EPA Responses to HD TRUCS Peer Review Comments

This document contains EPA’s responses to the comments received from an External Peer Review of the HD TRUCS tool. The peer review was conducted by Eastern Research Group (ERG) under Work Assignment 4-22 under EPA Contract 68HE0C18C0001. The contractor was asked to identify a group of independent subject matter experts and then facilitate each member’s review and comment of this report. The reviewers were asked for expert opinions on the methodologies, cost inputs of the tool, and whether they are likely to yield an accurate assessment of the true cost of ownership of vehicles and their subsystems. The specific charge questions and the reviewers’ detailed responses are provided in the Peer Review Report. The sections below include the text of the peer reviewers’ responses to each charge question in each of two categories—methodology/results and editorial content—followed by EPA’s responses.

Figure 1 M&R Cost Per Mile (2022\$/mi)

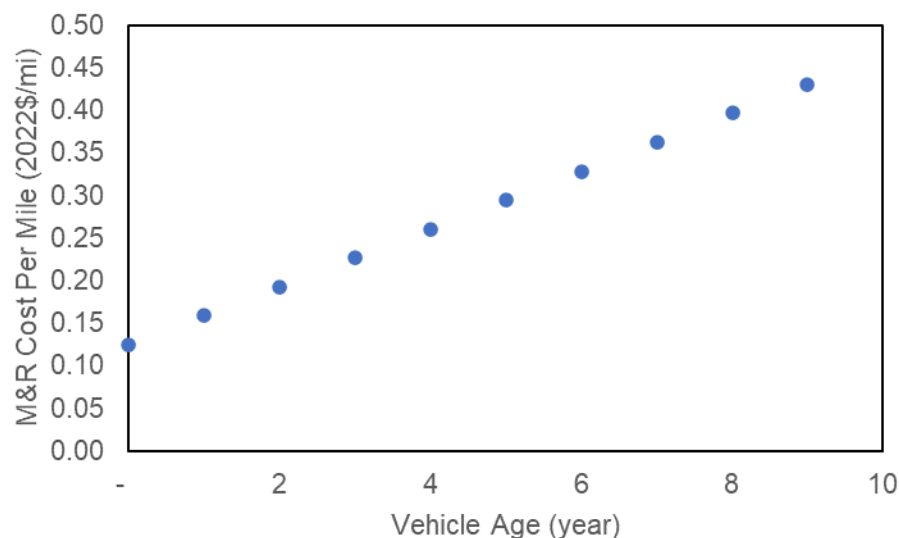
Reviewer Comment: Scheduled maintenance and replacement vary over the life of the vehicle. The cost increases over the vehicle's life as more replacement is needed (Auxiliary battery, tires, brakes, ICE components). Since maintenance costs are a benefit of BEV/FCV over ICE, a maintenance model is needed. Since it is incorrect, I am against using fixed maintenance costs (\$/miles) for each vehicle. The model has annual maintenance costs (\$/miles_year1, ... \$/miles_year10), but increase over the vehicle's life. That is true, but the costs have peaks due to some scheduled maintenance and replacement costs that occur when the vehicle hits a certain mile or time (year).

To establish a baseline cost for maintenance and repair of diesel-fueled ICE vehicles, we relied on the research compiled by Burnham et al. in Chapter 3.5.5 of “Comprehensive Total Cost of Ownership Quantification for Vehicles with Different Size Classes and Powertrains”^{i,ii} and used equations found in the 2022 BEAN tool (see the “TCO” tab).ⁱⁱⁱ Burnham et al. used data from Utilimarc and American Transportation Research Institute (ATRI) to estimate maintenance and repair costs per mile for multiple heavy-duty vehicle categories over time. M&R cost per mile (2022\$/mi) are shown in the figure below. As shown below, the M&R costs increase with both vehicle age and with miles travelled.

Figure 2 Modeled HVAC Power Demand of a Class 8 Transit Bus as a Function of Ambient Temperature

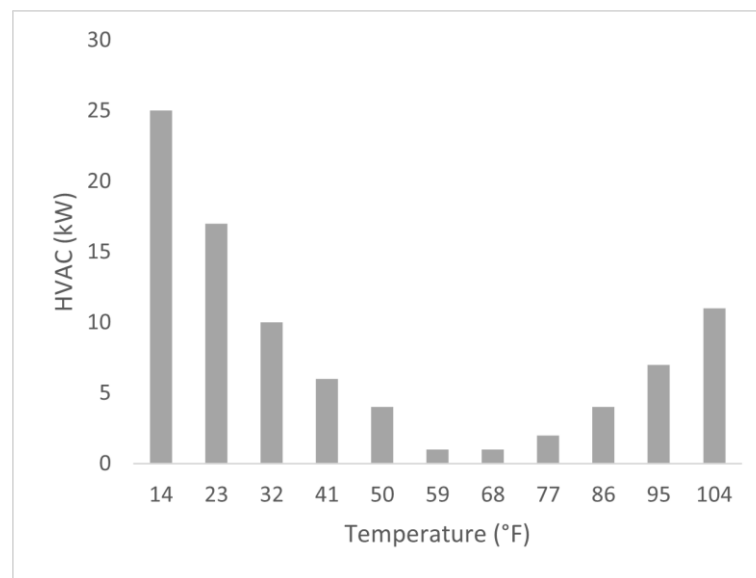
Reviewer Comment: The performance of BEV changes dramatically based on the region due to load, route, and HVAC needs. This needs to be considered but can be if the tool is restructured to simulate different regions.

agreed with the HVAC modeling approach described in Basma et. al.⁷¹ This physics-based cabin thermal model considers four vehicle characteristics: the cabin interior, walls, and materials, as well as the number of passengers. The authors modelled a Class 8 electric transit bus with an HVAC system consisting of two 20 kW-rated reversible heat pumps, an air circulation system, and a battery thermal management system. The HVAC control strategy is a traditional on-off controller. The modeled power demand as a function of ambient temperature for the Class 8 transit bus is shown in Figure 2. In response to our request for data in the NPRM on HVAC loads for BEVs, we received additional modeling data from one commenter that included HVAC loads for European long-haul tractors. We found the new data to be corroborative with our HVAC loads and the sleeper cab scaling factor; therefore, we continued to use the same HVAC power demand model in the final version of HD TRUCS.
